DRAINAGE PLAN
STA. 145+00 TO 150+00

FARRINGTON HIGHWAY INTERSECTION IMPROVEMENTS
AT NANAKULI AVENUE AND HALEAKALA AVENUE
Federal-Aid Project No. STP-093-1(22)

CONTRACT CHANGE ORDER NO. 27
Attachment 1

FED. ROAD DIST. NO.	STATE	FEDERAL AID PROJ. NO.	FISCAL YEAR	SHEET NO.	TOTAL SHEETS
HAWAII	HAW.	STP-093-1(22)	2013	CO. 73	230

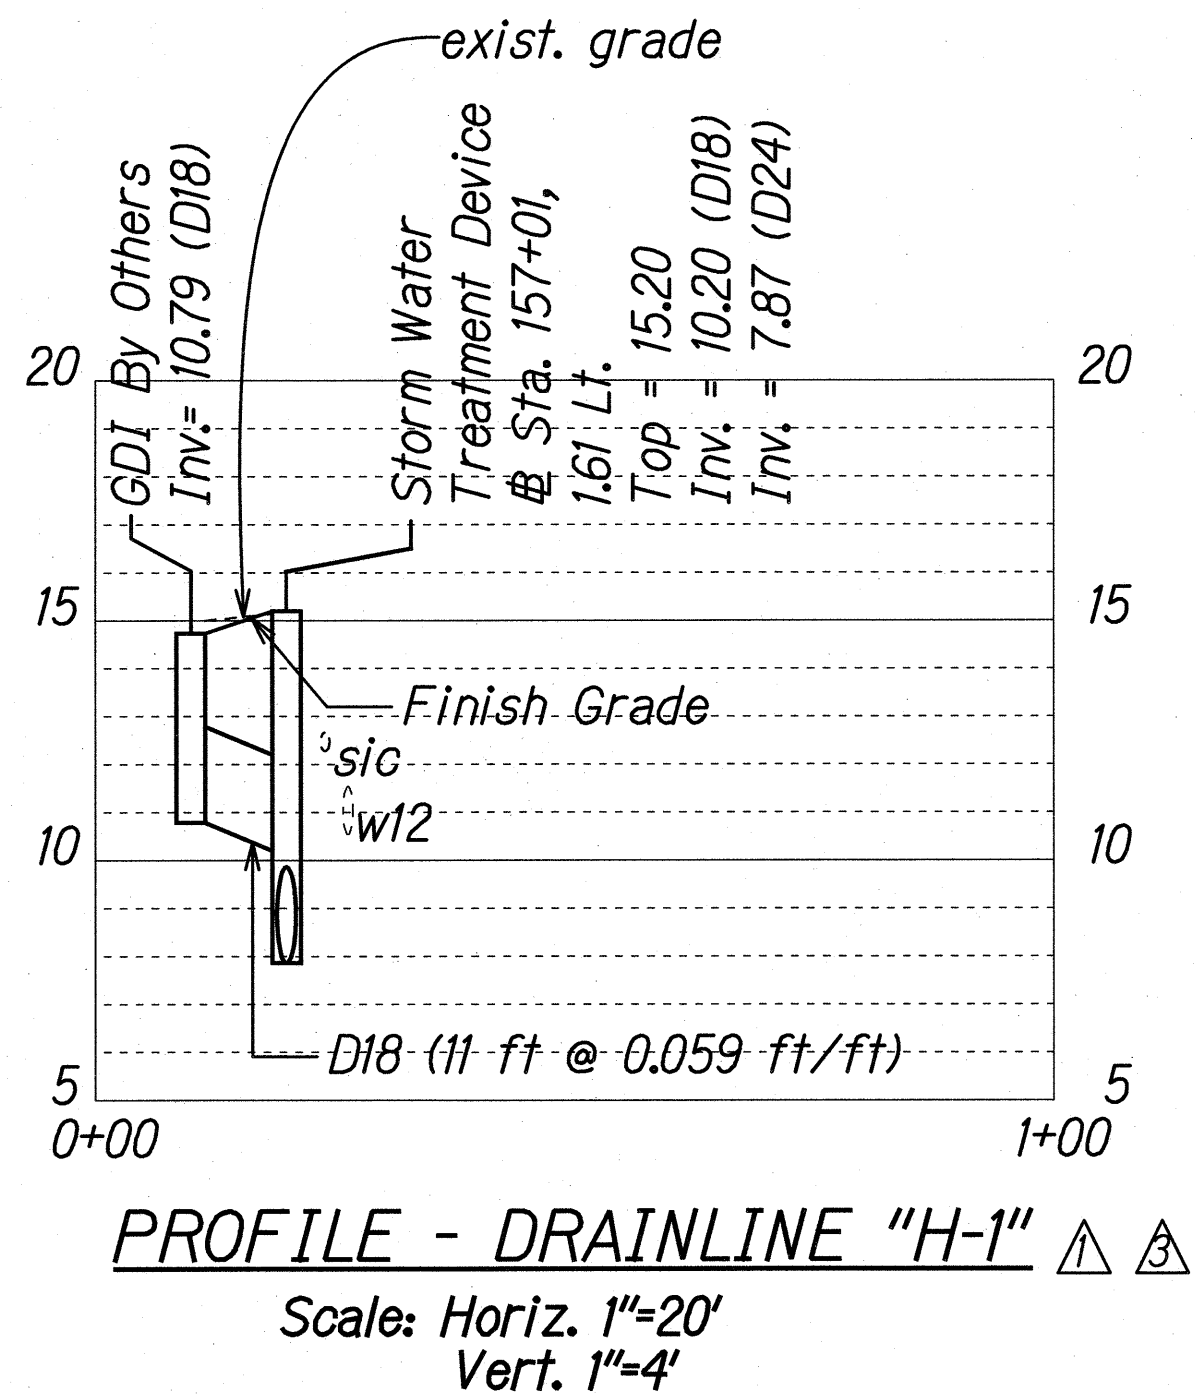
11/17/17	Revised Drainline "H-1"
8/7/17	Deleted Profiles
4/22/15	Revised Drainline "H-1", "J", "K-1", "L-1" & "M-1"
DATE	REVISION
